LSD Ebersole Center Food Service

Bid Pack 2, Addendum No. 1

Narrative of Changes

Project Name:	Ebersole Center Food Service – Equipment Replacement & Renovations SO-1853	Date:	April 3, 2026
Project Location:	3400 2 nd St Wayland, MI 49348	Architect's Project #:	26000750A
Owner/Client:	Lansing School District	Attention:	David Beckering
Issued to:	Beckering Construction	Email:	djb@beckering.com
City/State:	Grand Rapids, MI	Zip:	49548

DRAWING NUMBER:
A101

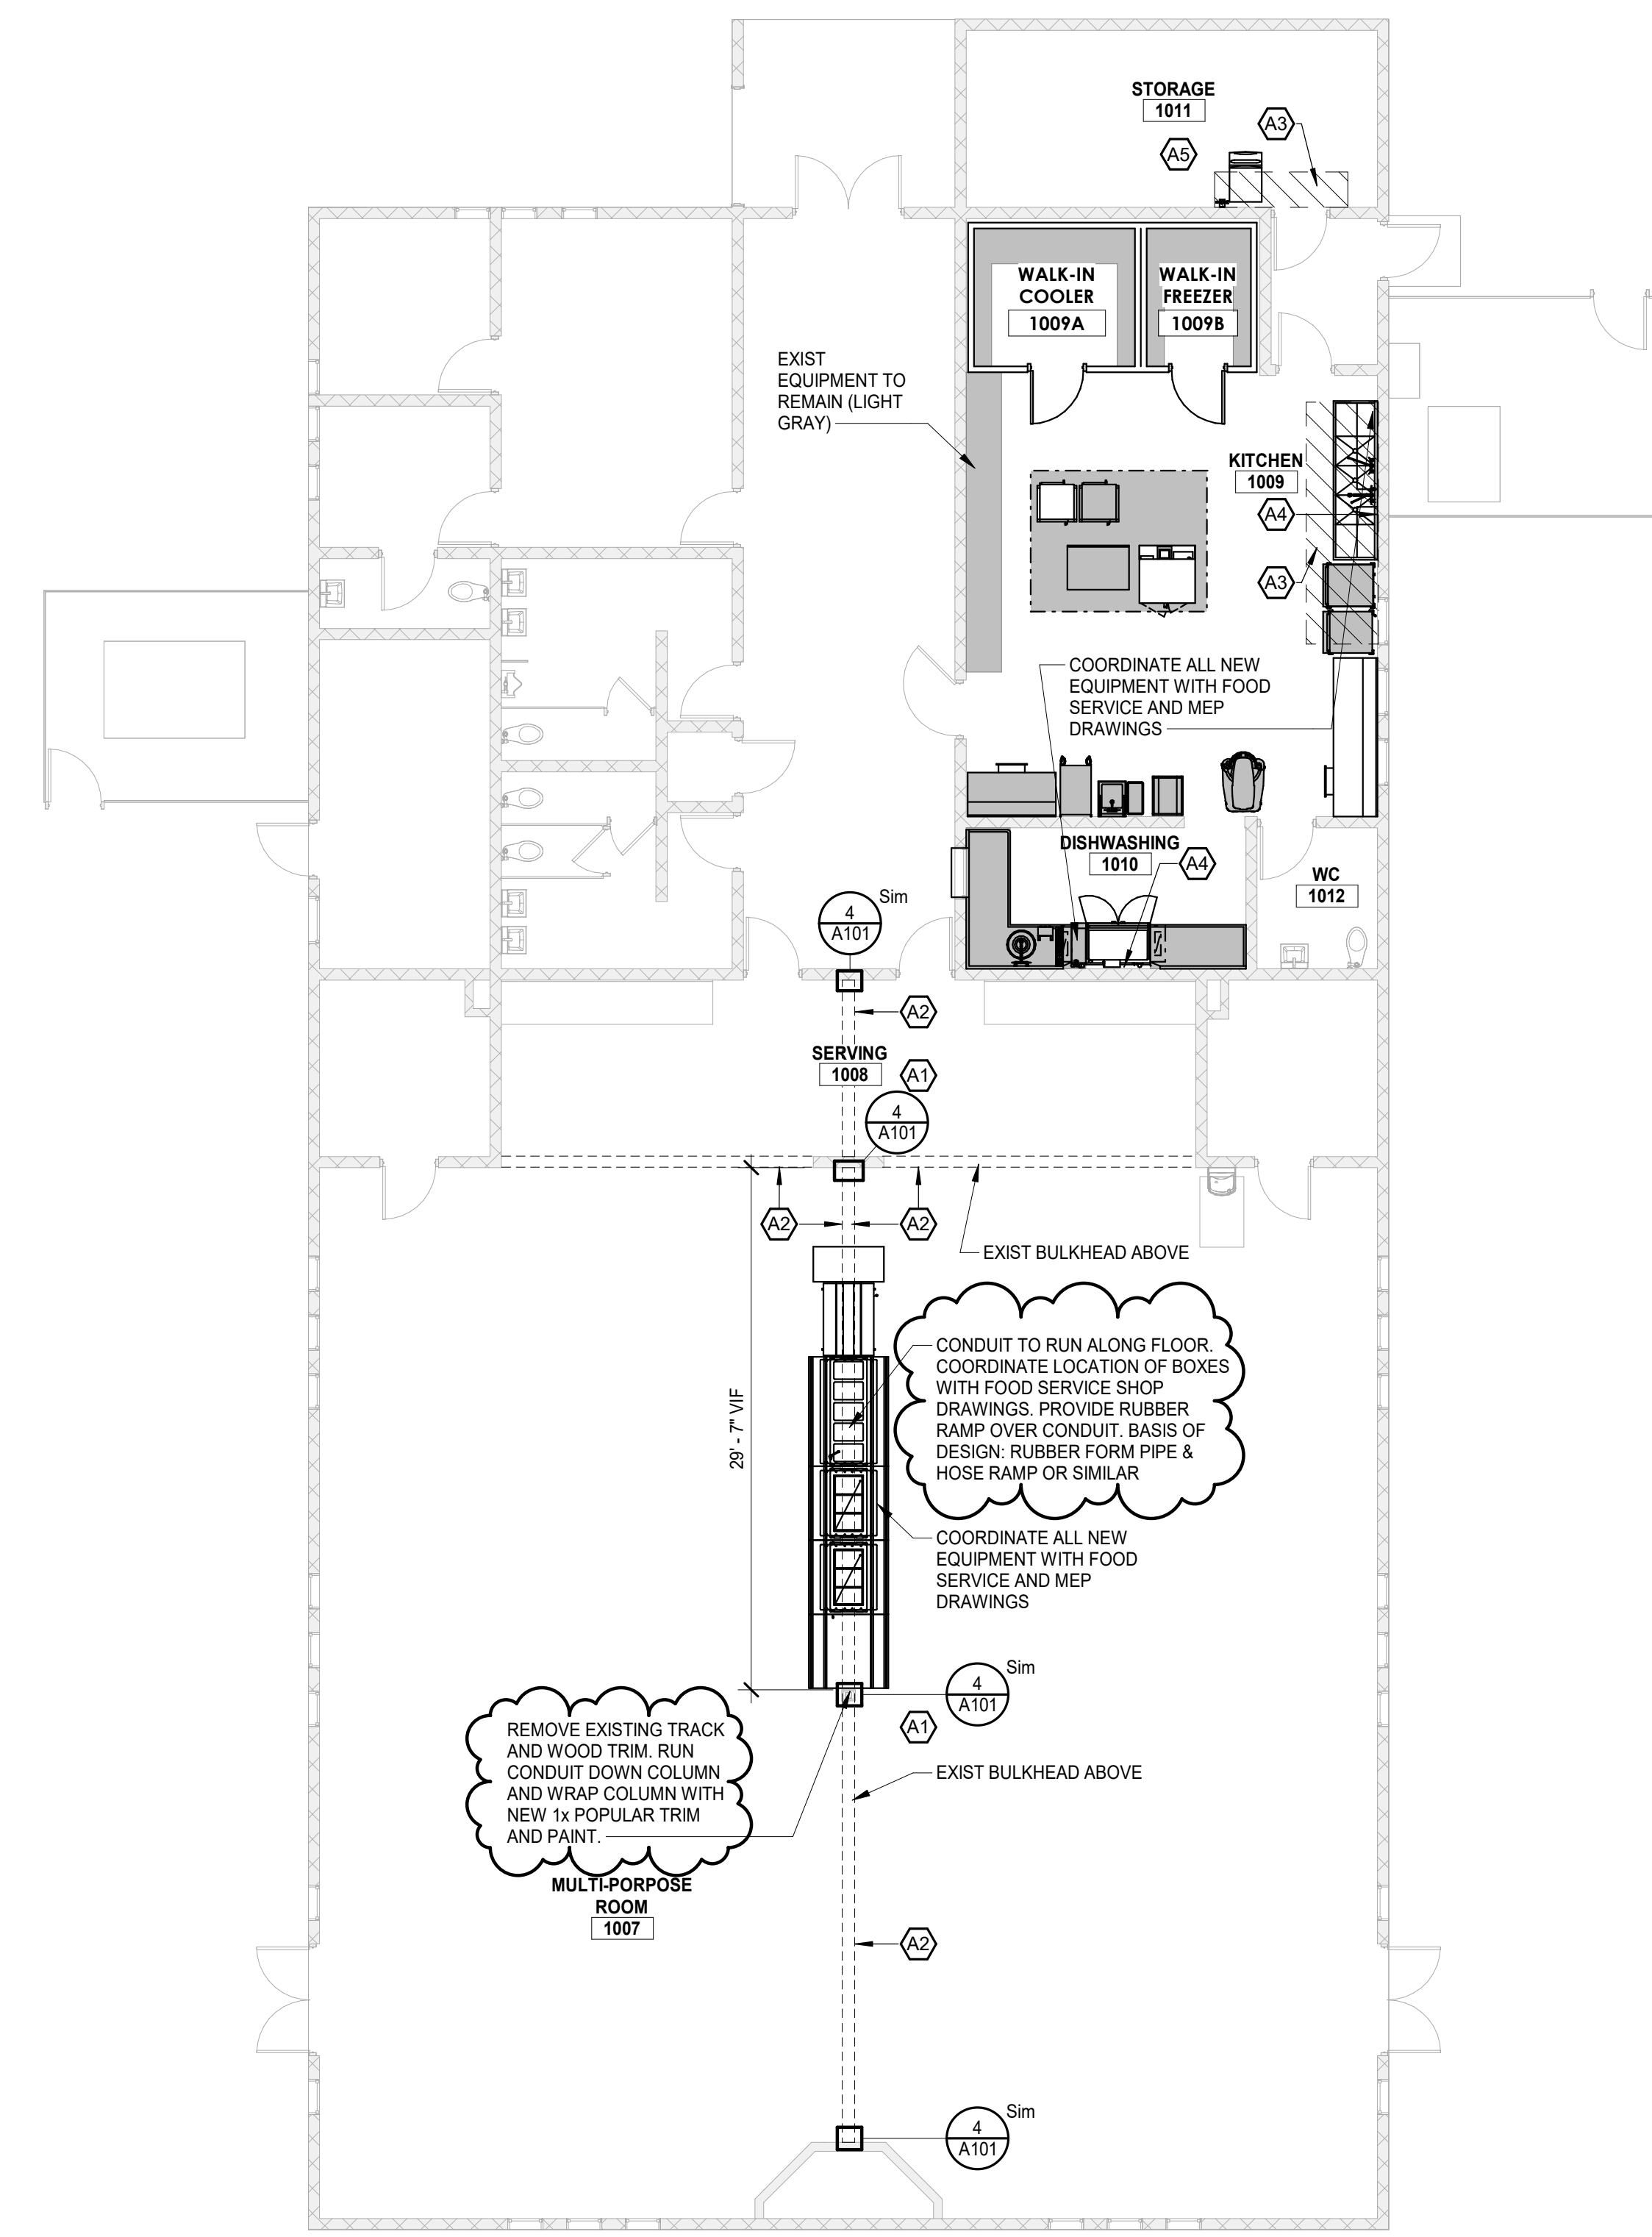
- A101 – FIRST FLOOR AND CEILING PLANS (Reissued)
 - Added paint specifications.
 - Revised note regarding column wrap and conduit running inside of column wrap and across the floor.
 - Revised note regarding painting of trim

DRAWING NUMBER: **E100**

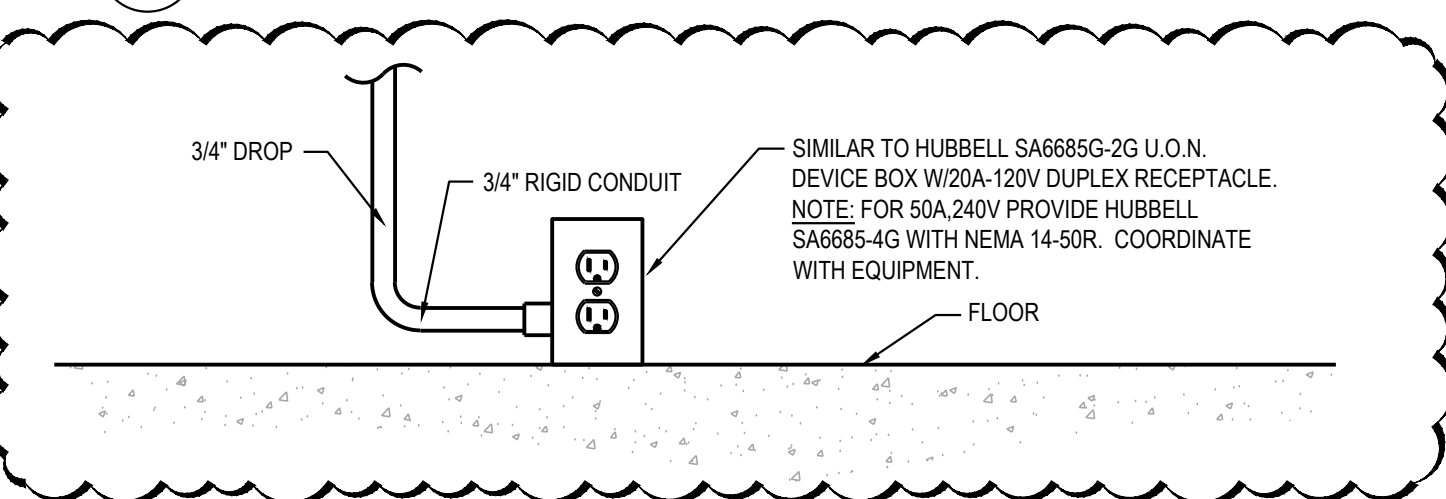
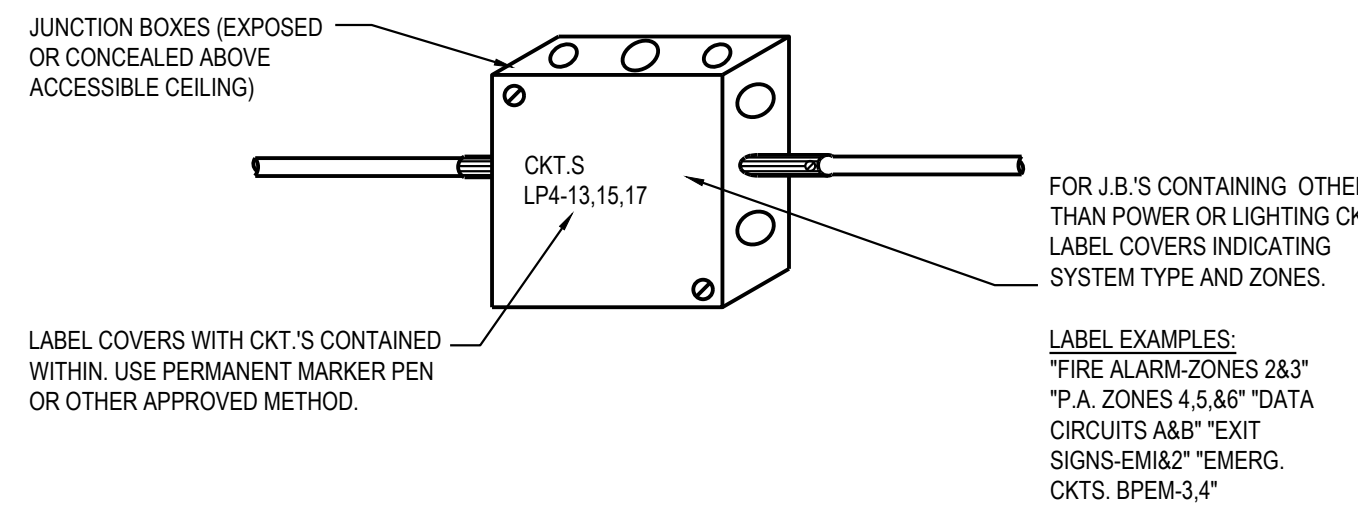
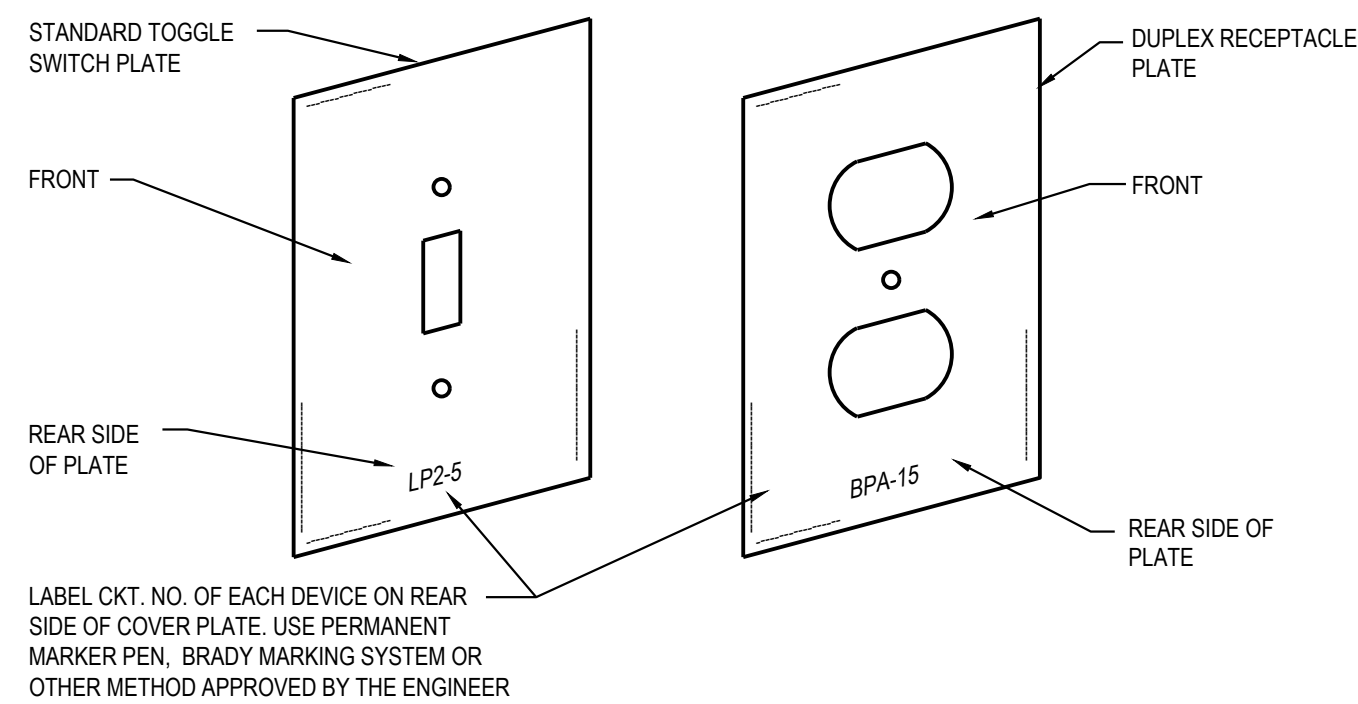
- E100 – DETAILS, SYMBOL LEGENDS & SPECIFICATIONS
 - Added new type b in fixture schedule
 - Added Columbia manufacturer to the schedule as approved
 - Allow watt stopper as approved equal for lighting controls
